DOUGLAS COUNTY
COLORADO

Preliminary Plan Staff Report

Subject: **Pinery Meadows Preliminary Plan**

Project File: **SB2025-009**

PRELIMINARY GRADING AND SLOPE ANALYSIS PLAN

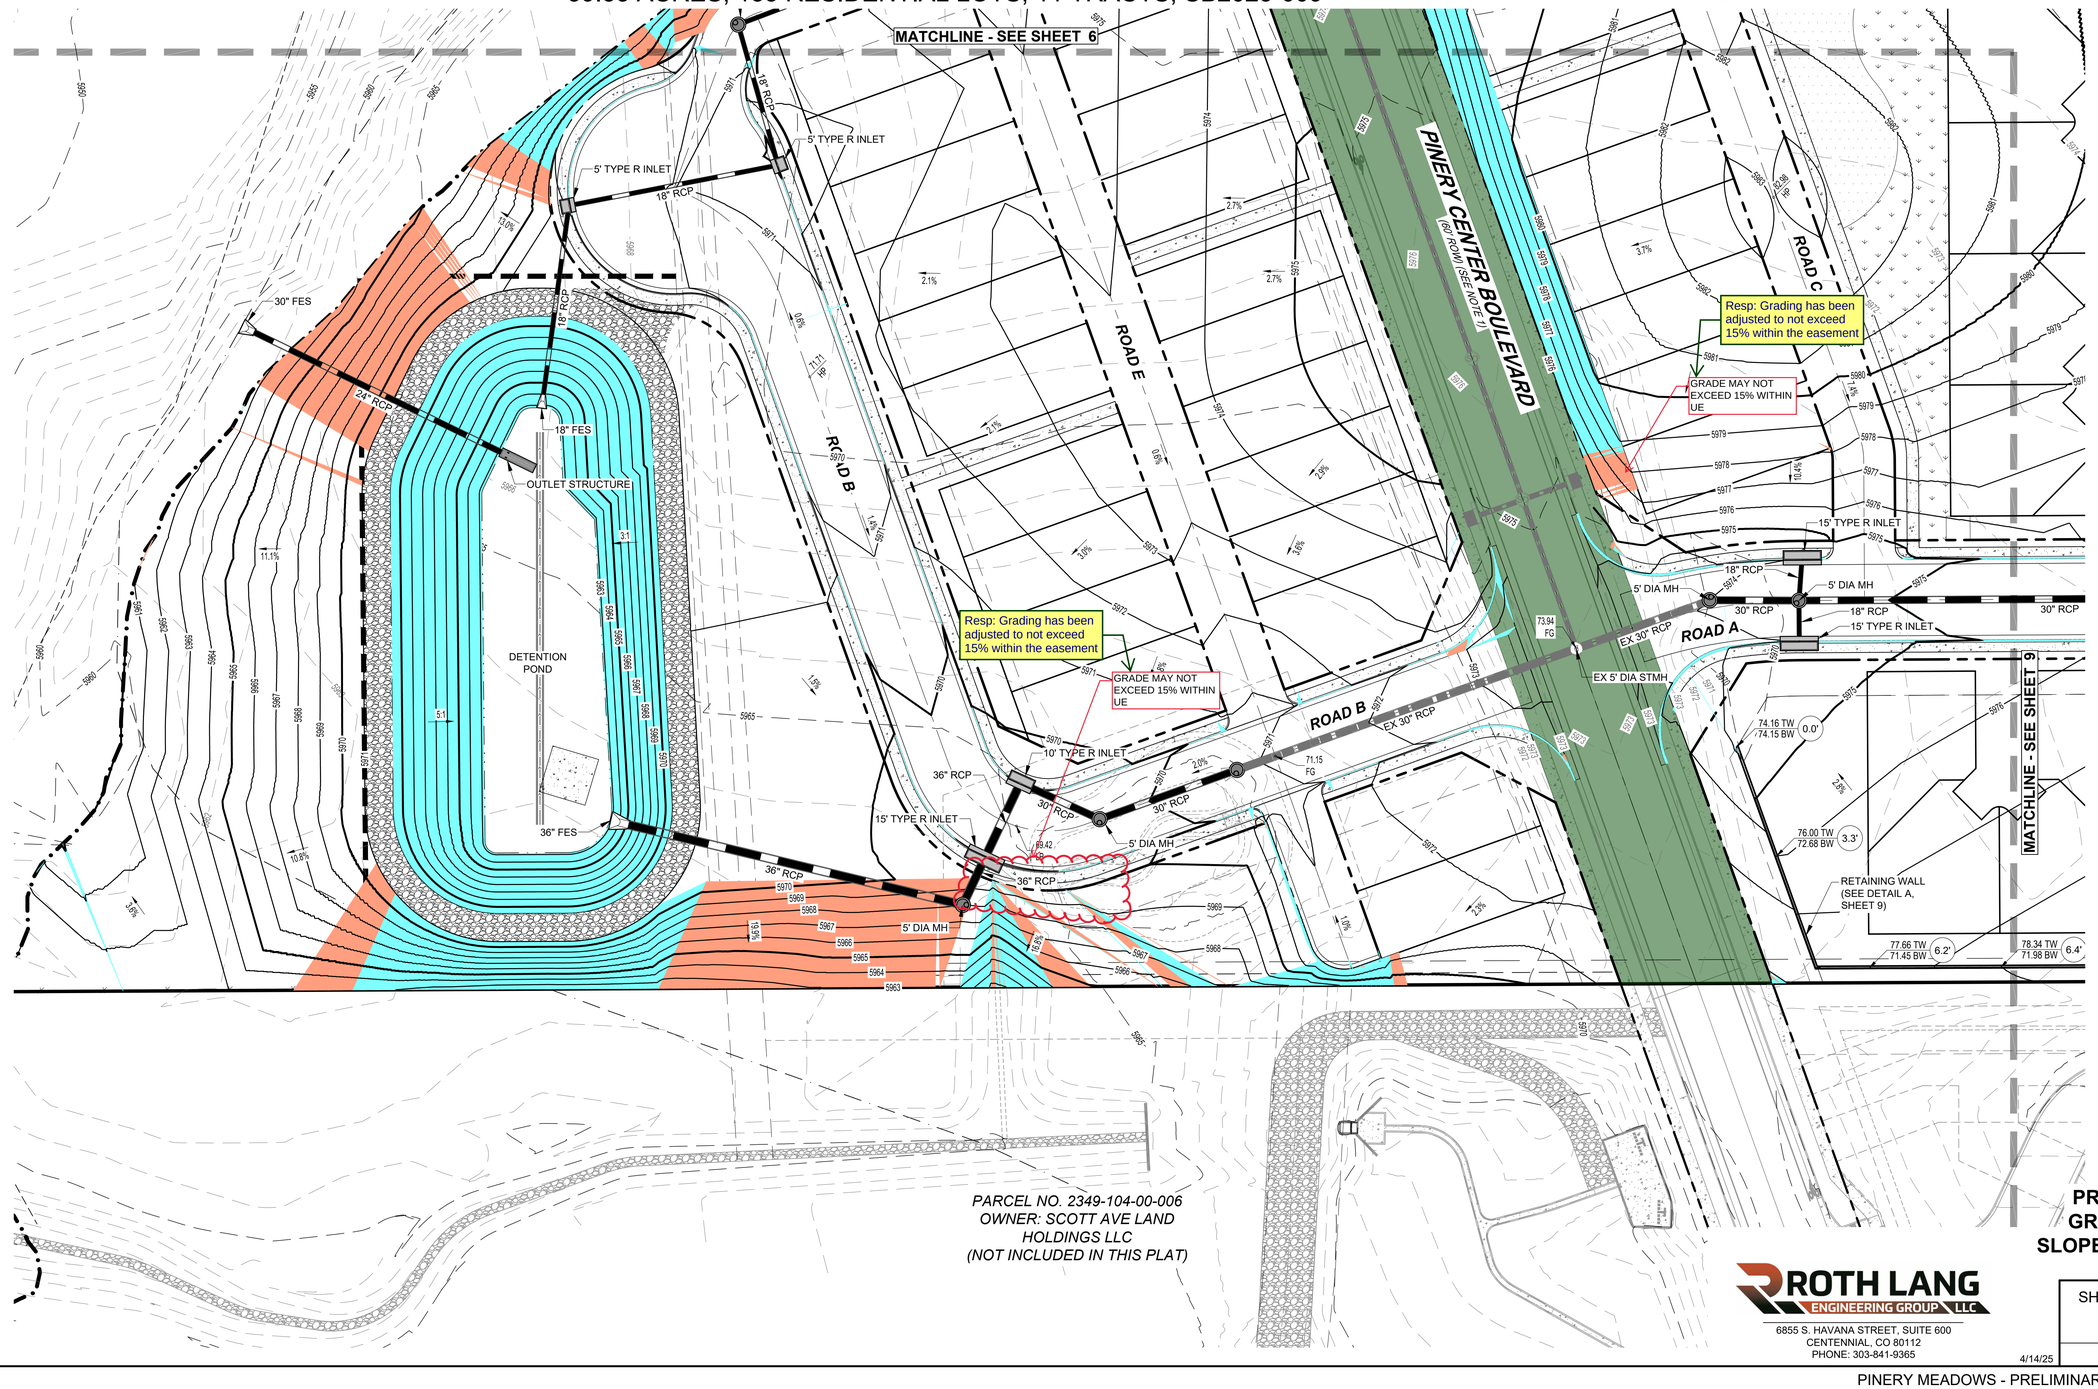
48" FES
48" RCP
6' DIA MH
73.06 FG
ROAD A
SWALE
69.40 FG/ME
5' TYPE R INLET
Resp: Grading has been adjusted to not exceed 15% within the easement
GRADE MAY NOT EXCEED 15% WITHIN UE
ROAD E
71.50 FG
5' DIA MH
ROAD F
5' DIA MH
18" RCP
PINERY CENTER BOULEVARD
(60' ROW) (SEE NOTE 1)
ROAD C
GRADE MAY NOT EXCEED 15% WITHIN UE
Resp: Grading has been adjusted to not exceed 15% within the easement
MATCHLINE - SEE SHEET 8
MATCHLINE - SEE SHEET 7
